ECM Calibration: Enhancement to Shifting Performance

Service Category Drivetrain

Section Automatic Transmission/Transaxle

YEAR(S)	MODEL(S)	ADDITIONAL INFORMATION
2008 – 2011	LX570	Transmission(s): 6AT VDS(s): HY00W, HY7AX

Figure 1. Location of Authorized Modifications Label on 2008 – 2011 LX 570

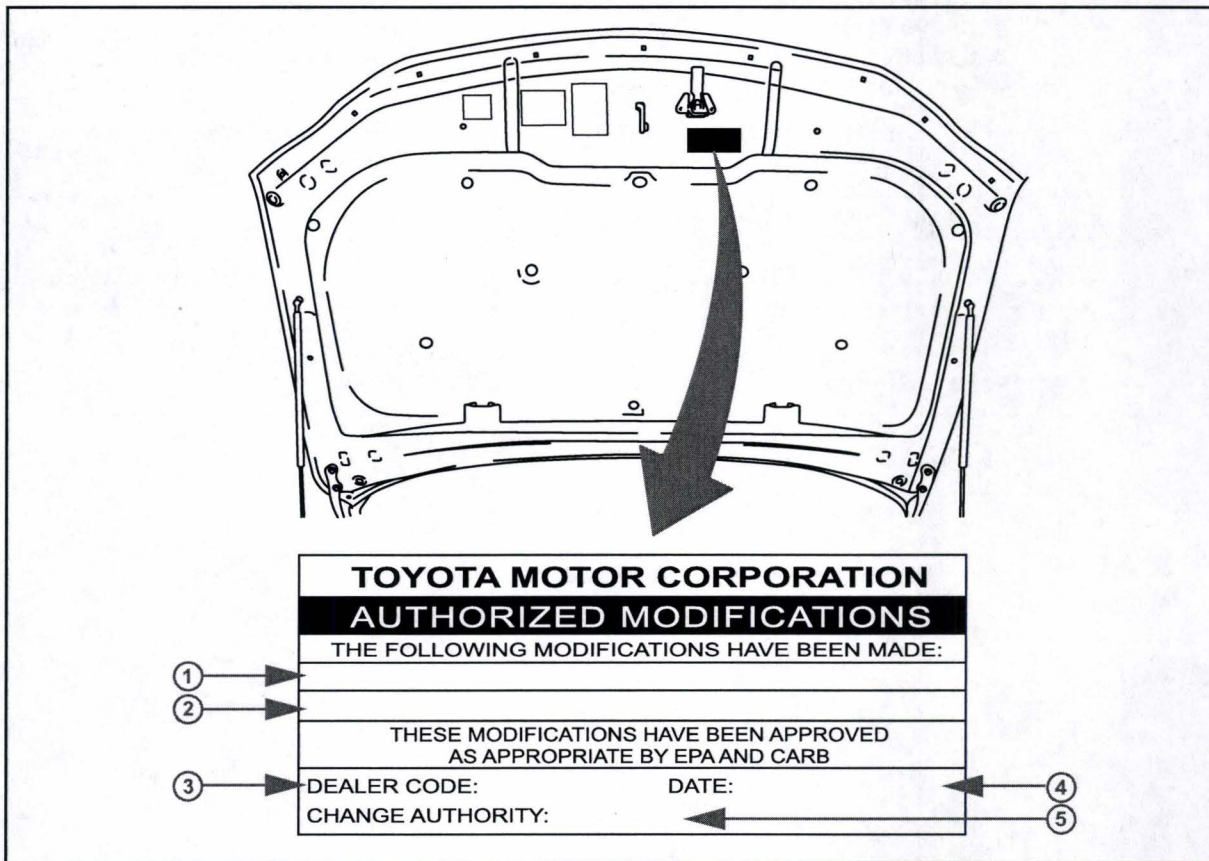
2. Check for the Authorized Modifications Label affixed to the vehicle in the location shown in Figure 1. Confirm if the ECM (PCM) calibration has been updated. If the calibration ID listed is NOT the latest ECM (PCM) calibration — go to step 3.

B. Affix the Authorized Modifications Label to the vehicle at the location shown in Figure 1. The Authorized Modifications Label is available through the MDC, P/N 00451-00001-LBL.

A. Using a permanent marker, enter the following information on the label:

- ECM part number [Refer to the **Parts Information** section for the **CURRENT PART NUMBER**]
- Calibration ID(s) [Refer to the **Calibration Identification Chart** for the **NEW CALIBRATION ID**]
- Dealer Code
- Repair Date
- Change Authority [**This bulletin number**]
